ADDENDUM NO. 1

DATE: March 20, 2020
FROM: City of Grand Junction Purchasing Division
TO: All Offerors
RE: Las Colonias Amphitheater Addition IFB-4774-20-DH

**LAS COLONIAS
AMPITHEATER ADDITION**

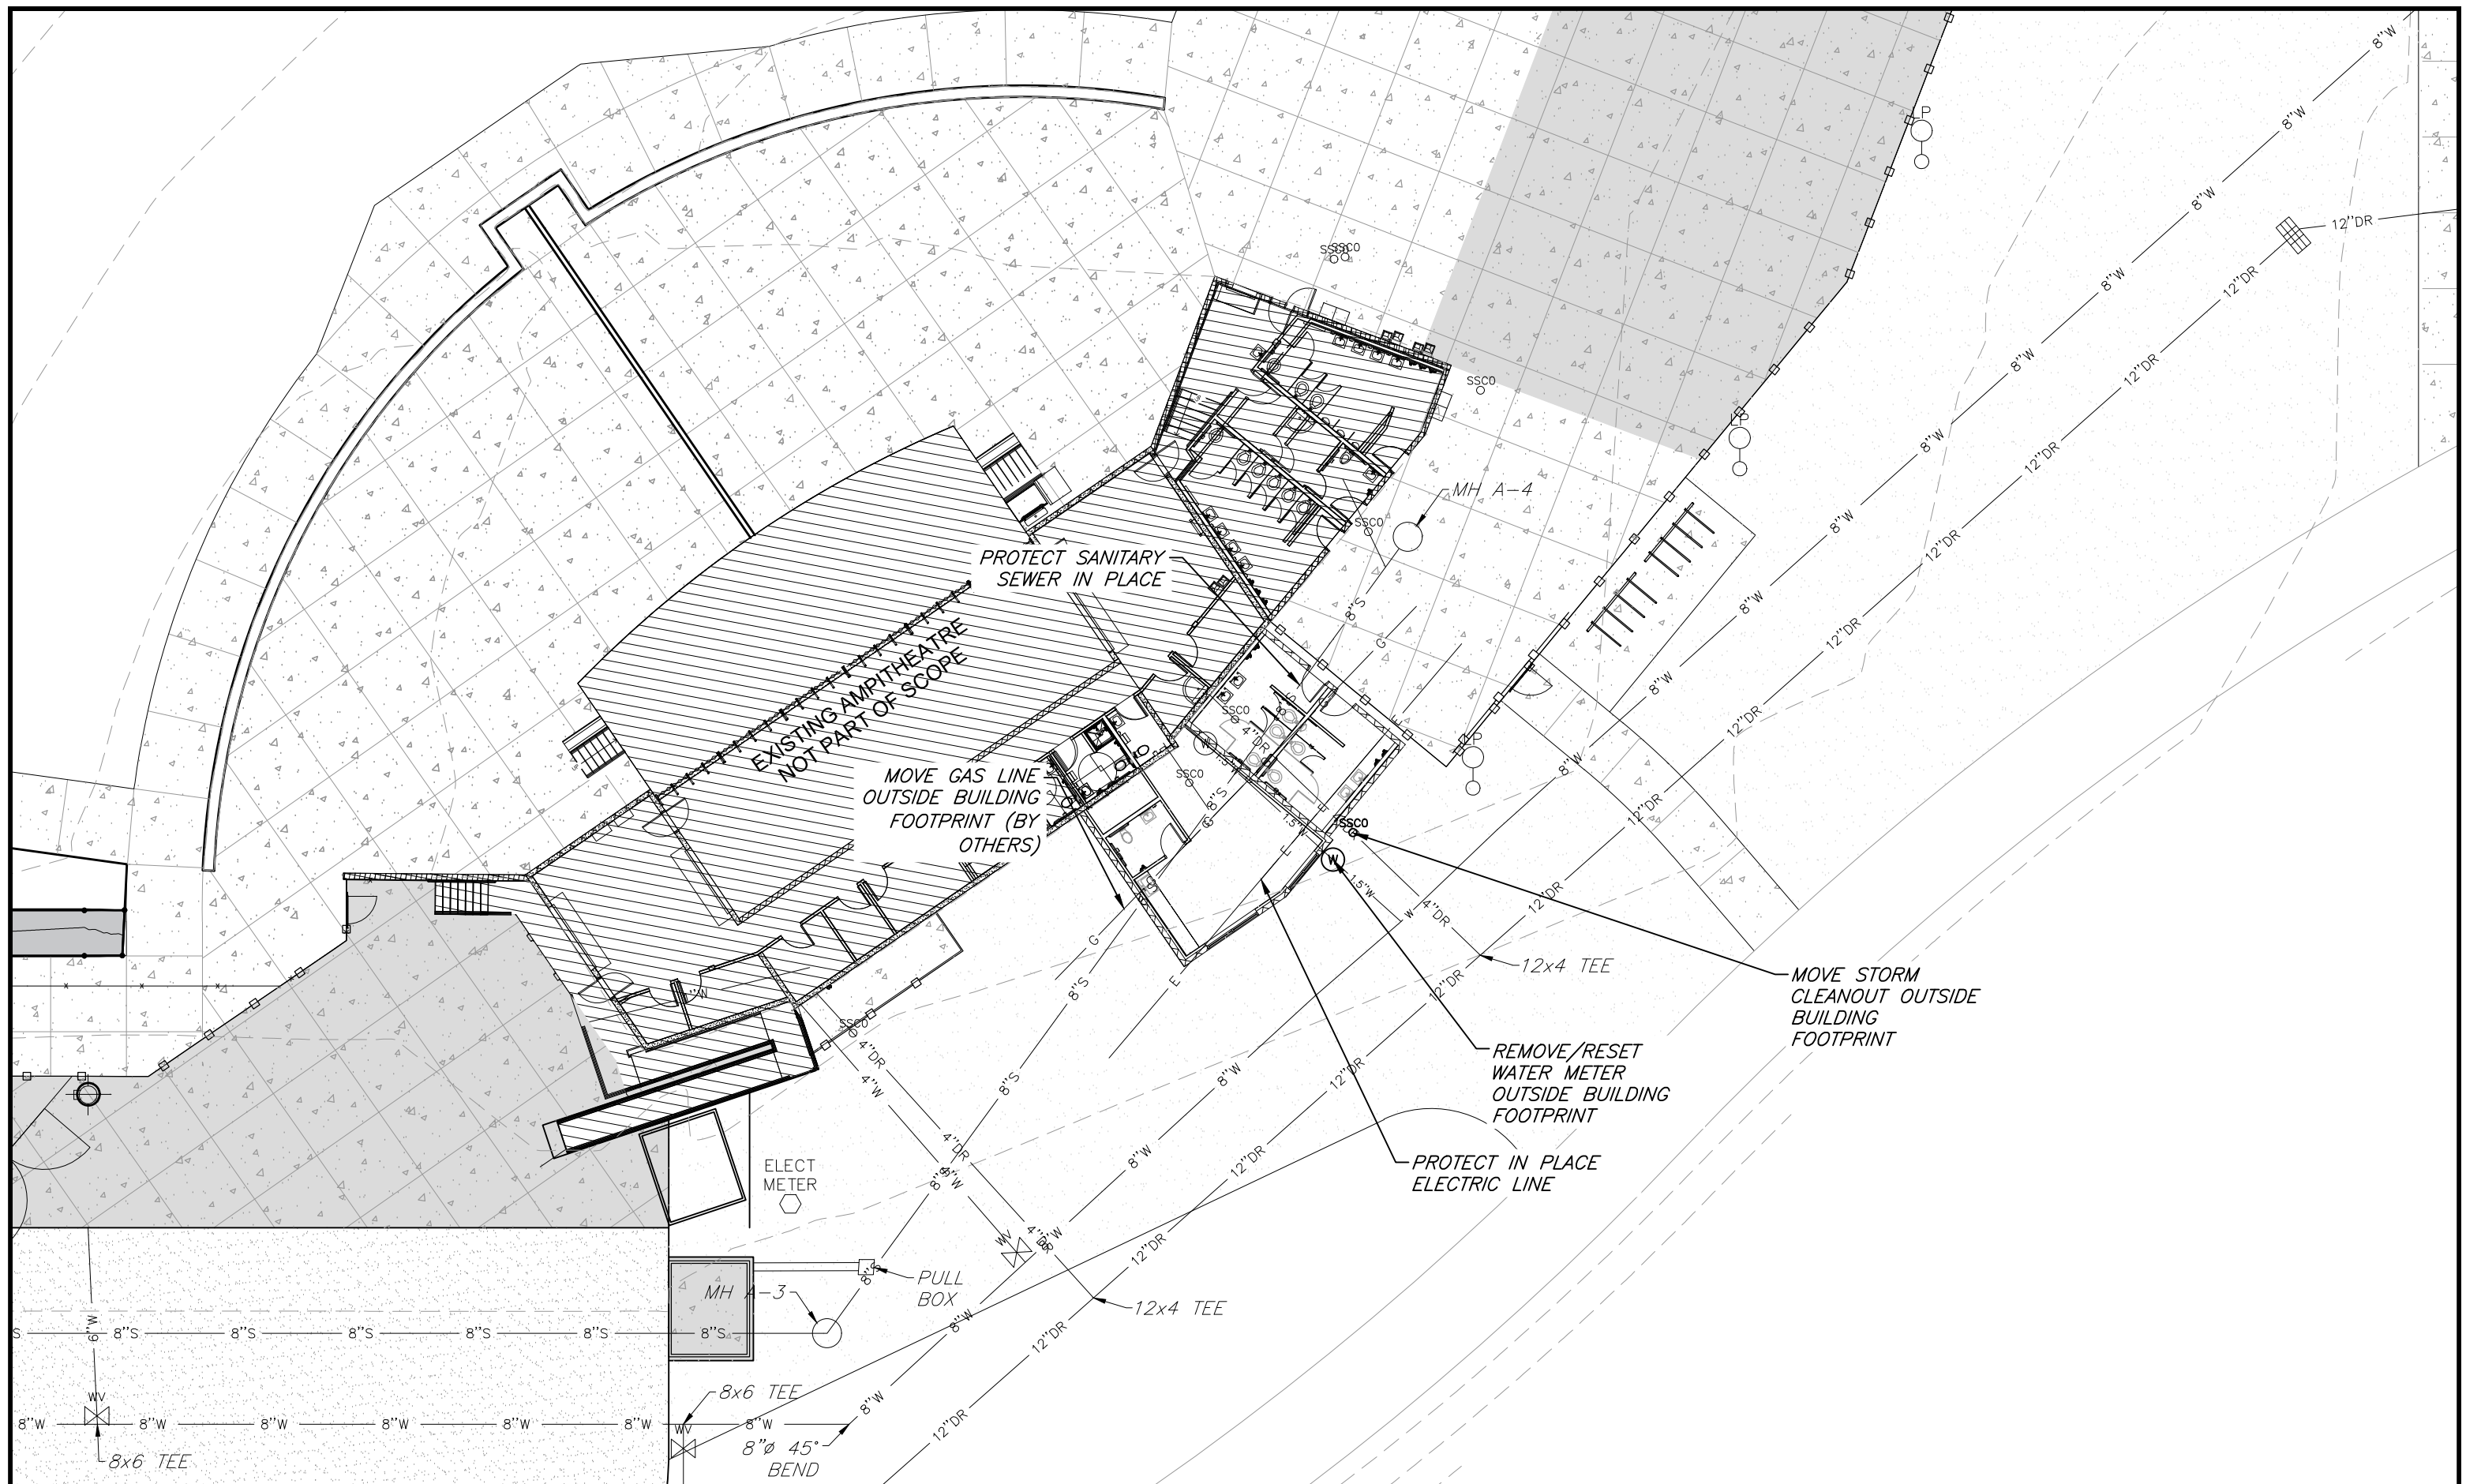
1. See attached Site Utility Plan for the project.
